IMPORTANT SAFETY RECALL

[NHTSA Recall No. 26V339](#)

Touring Coil Suspension Shock Bolt Replacement

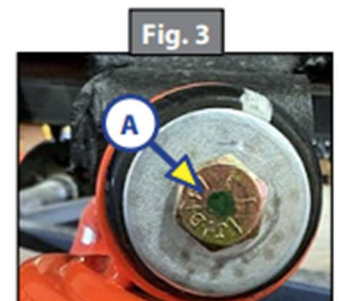
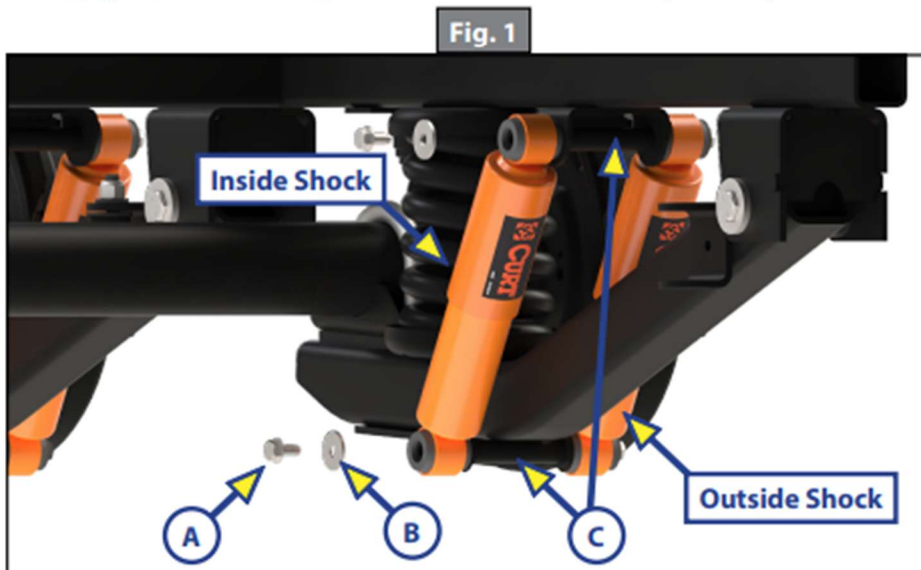
1. Starting with the inside shocks, loosen and remove the two existing 3/8"-16 x 3/4" thread forming screws (Fig. 1A) and washers (Fig. 1B) securing each shock absorber onto its posts (Fig. 1C). Retain washers (PN 249853) for reinstallation in Step 2.
2. Reinstall previously-removed washers onto two new 3/8" - 16 x 3/4" Grade 8 hex head bolts.
3. Apply two threads of Loctite® Blue 242® to the Grade 8 bolt threads (Fig. 2).
4. Install new bolt assemblies by hand for a minimum of three full threads (or three turns) before proceeding to Step 5.
5. Torque new Grade 8 bolts to 30 ft-lbs. Do not over-torque bolts.
6. Repeat procedure on all other inside and outside shock absorber bolts.
7. Once all bolts have been tightened to 30 ft-lbs spec, apply a green or yellow dot of epoxy paint (Fig. 3A) onto the newly-installed bolt to indicate completed repair status.
